UNITED STATES PATENT AND TRADEMARK OFFICE

APPLICATION NO.	FILING DATE	FIRST NAMED INVENTOR	ATTORNEY DOCKET NO.	CONFIRMATION NO.
09/883,941	06/20/2001	Seiji Umemoto	Q65071	2681

Office Action Summary

DETAILED ACTION

【 図 1 】

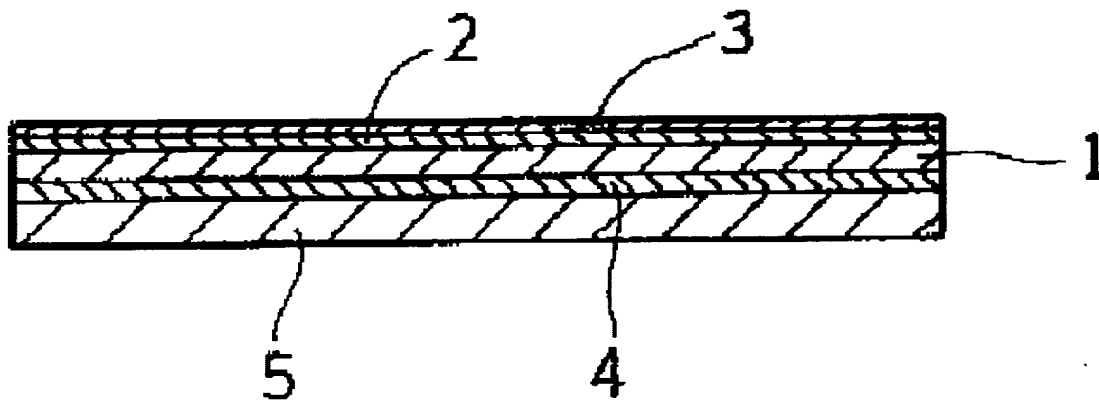
5. Claims 1-4 and 7 are rejected under 35 U.S.C. 102(b) as being anticipated by Shozo et al., (Shozo), JP 06-222352 (provided by the applicant).
6. Shozo discloses a resin substrate wherein a transparent resin plate (1) has at least a transparent conductive layer (3) via a dielectric thin film (2) (applicant's

transparent layer) with a lower refractive index (n_2) than the resin plate (1) (abstract; Fig. 1).

Accordingly, claims 1 and 4 are anticipated.
